FORM APPROVED
OMB NO. 1004-0137
Expires: January 31, 2018**SUNDRY NOTICES AND REPORTS ON WELLS**
*Do not use this form for proposals to drill or to re-enter an abandoned well. Use form 3160-3 (APD) for such proposals.*5. Lease Serial No.
NMNM084402

Fasken Oil and Ranch, Ltd. requests to recompleate the above well to the Wolfcamp. Please see attached Procedure, Proposed, and Current Wellbore Diagram.

Recommended Workover Procedure
Ross Federal No. 5
660' FNL & 660' FEL
Sec 4, T21S R24E

Ross Federal No. 5
30-015-33592
FASKEN OIL AND RANCH
Conditions of Approval

Proposed as of 3-20-17

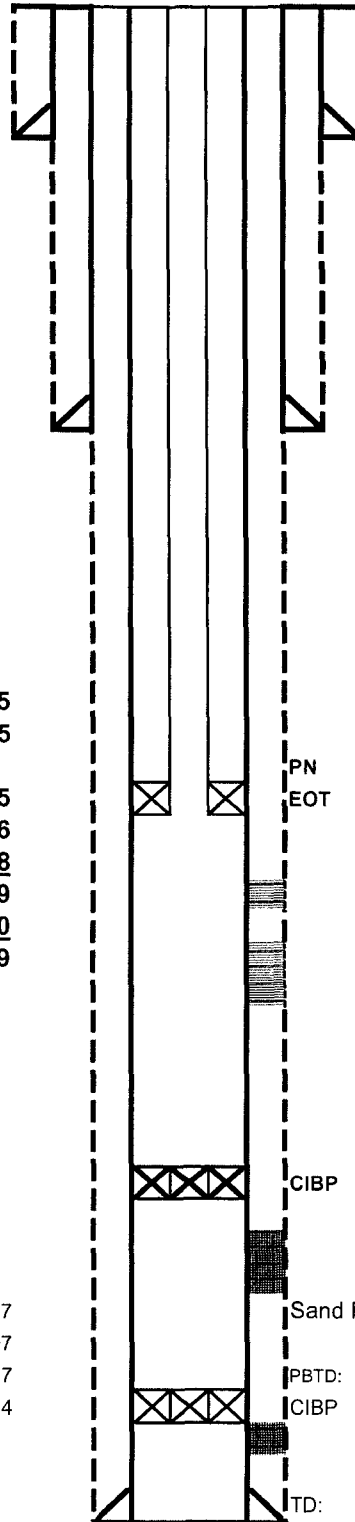
4. NDWH, NU BOP.
5. Release packer, POW with tubing and packer.
6. RIW with 5-1/2" CIBP, 4' perforated sub, SN, 2-3/8 EUE 8rd 4.7#/ft L-80 AB Modified tubing, and set CIBP at ~~+/- 9410'~~ ^{9410H} (minimum 50' above top perforation at 9463').

9. RU cementers pump 34 bbls 9.5 ppg mud laden brine water containing 12.5#/bbl salt gel, 1 bbl freshwater spacer and spot 25 sx class "H" cement (1.17 cuft/sk yield) above CIBP 9410' for a PBTD of 9212' (calc 9212 w/ yield 1.06 cuft/sk). Displace cement with 1 bbl fresh water spacer and 6 bbls mud laden brine water followed by 29 bbls 2% Kcl water. ' . POW to 7520' and WOC 8 hours and tag plug at 9212'.

Proposed 25 sx"H"9410'-9212', Plug #2, Tag

Proposed CIBP 9410'
